TECHNICAL SERVICE BULLETIN

TSB #:	TB-IC 0913	ENGINE:	6.0 LITER POWERSTROKE AND 6.0 LITER NAVISTAR VT 365
DATE:	10/30/2013	REVISION:	5/20/2016

6.0 LITER INJECTOR CLAMP CLEARANCE BULLETIN

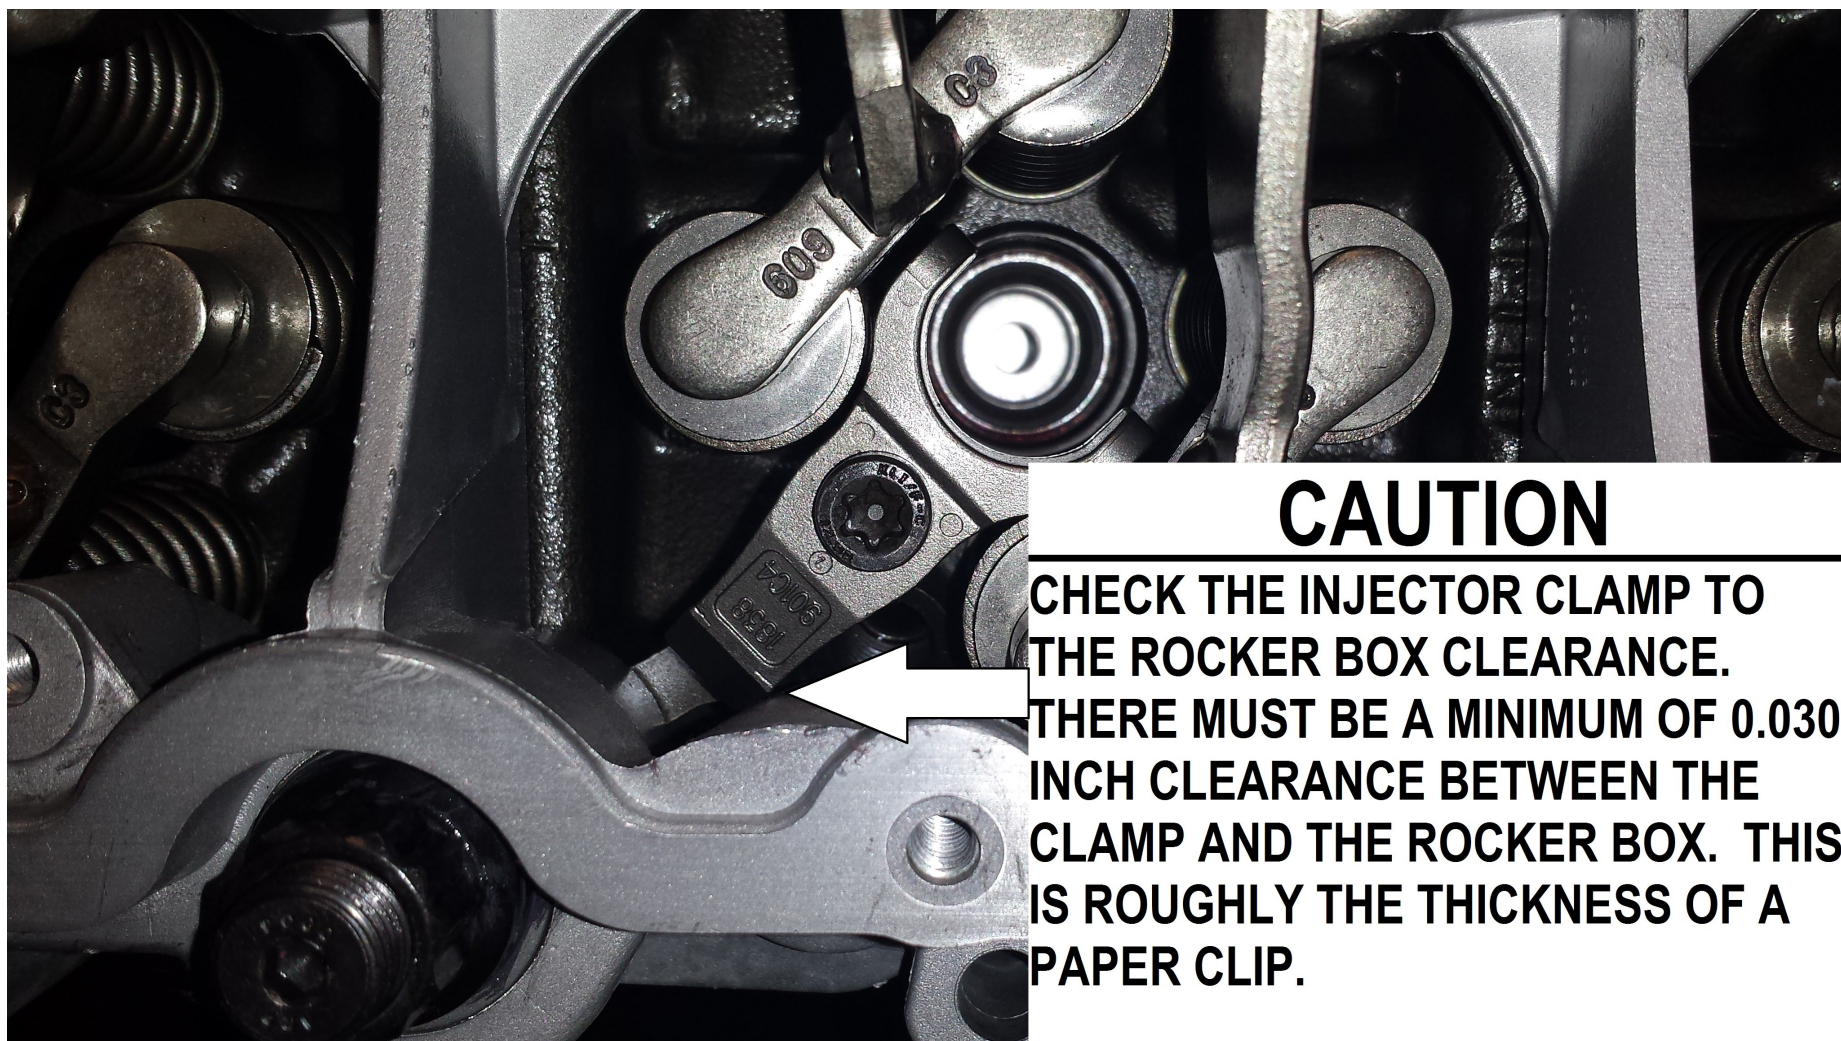
CHECK THE INJECTOR CLAMP TO THE ROCKER BOX CLEARANCE. THERE MUST BE A MINIMUM OF 0.030 INCH CLEARANCE BETWEEN THE CLAMP AND THE ROCKER BOX. THIS IS ROUGHLY THE THICKNESS OF A PAPER CLIP.
